MODELS 281/288

New carburettor

HS 228 B

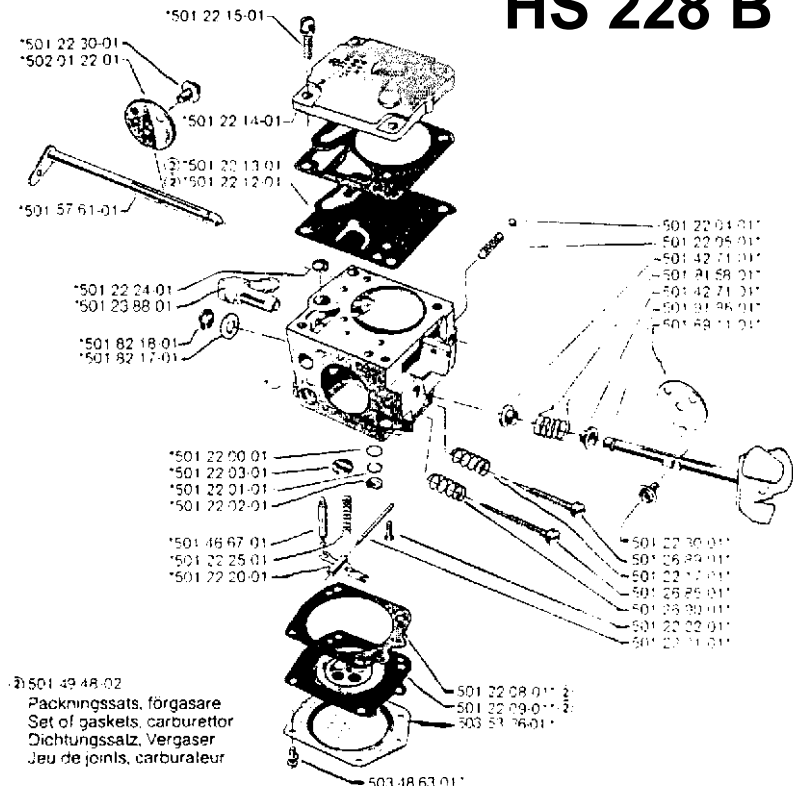
Experiences from the field tell us that the carburettor for the models 281/288 works better without governor.

The carburettor HS 228 A with governor is therefore replaced by HS 228 B without governor.

The change is introduced from serial number: 281-0170578
288-0170406

New Ref. No.	Description	Excluded Ref. No.
503 28 01-18	Carburettor compl.	501 91 18-02
	Governor	504 86 00-05
	Washer	501 81 90-01
	Gasket	501 48 50-01

NOTE! It is very important that the maximum rpm does not exceed 12500 rpm/min. A leaner adjustment causes loss of power and overheating of the engine which leads to engine damage.
